Product Change Notice (PCN)

PCN Number: PCN-0450036R-01

Product(s) Affected: MD-S series (part numbers MD-40S, MD-60S, MD-70S, MD-80S, MD-90S).

Old Design (MD-40S, MD-60S, MD-70S, MD-80S)

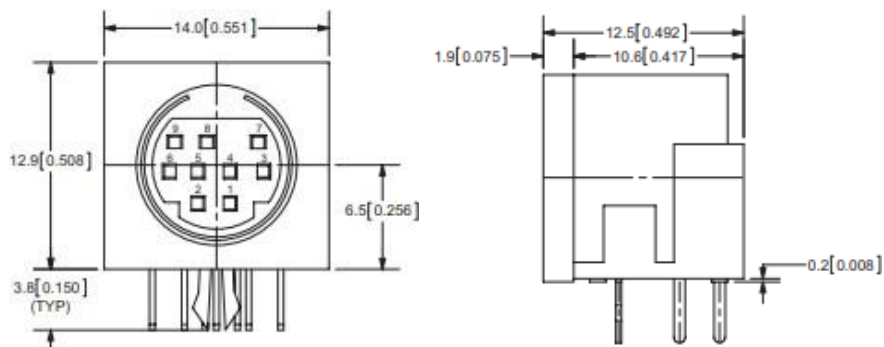
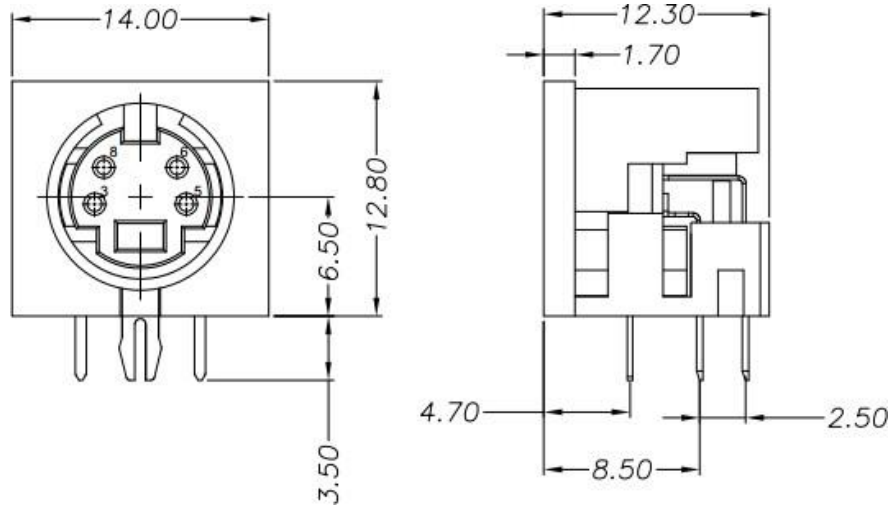
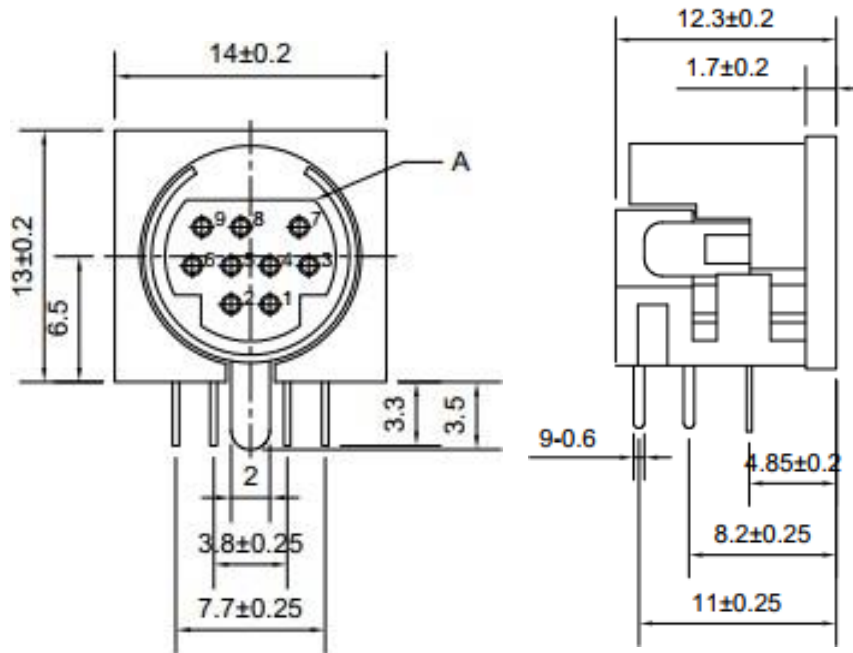
Description of Change: minor dimensional changes, such as pin length, and materials changes, as shown below.

New Design (MD-40S, MD-60S, MD-70S, MD-80S)

New Design (MD-90S)

Old Design Materials

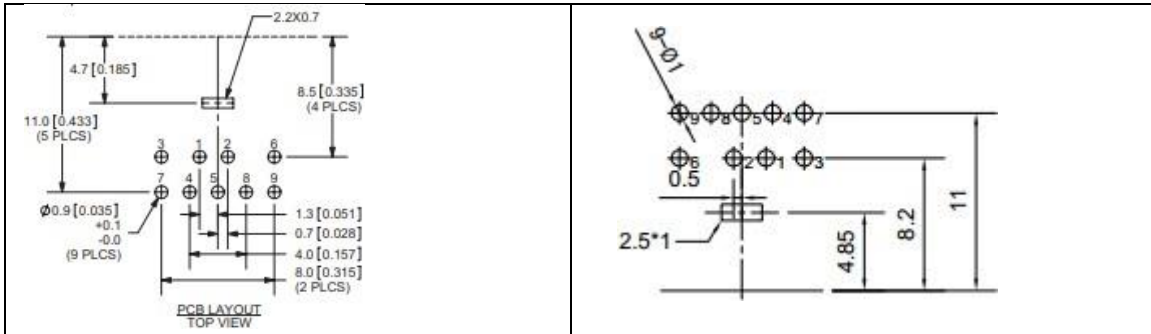
MATERIAL	PLATING
earth terminal	brass	tin
contact terminals (1~8)	phosphor bronze	silver
housing	PBT

MATERIAL	PLATING
body	PBT+30%GF (UL94V-0)	
pins	brass	tin
shield	brass	nickel
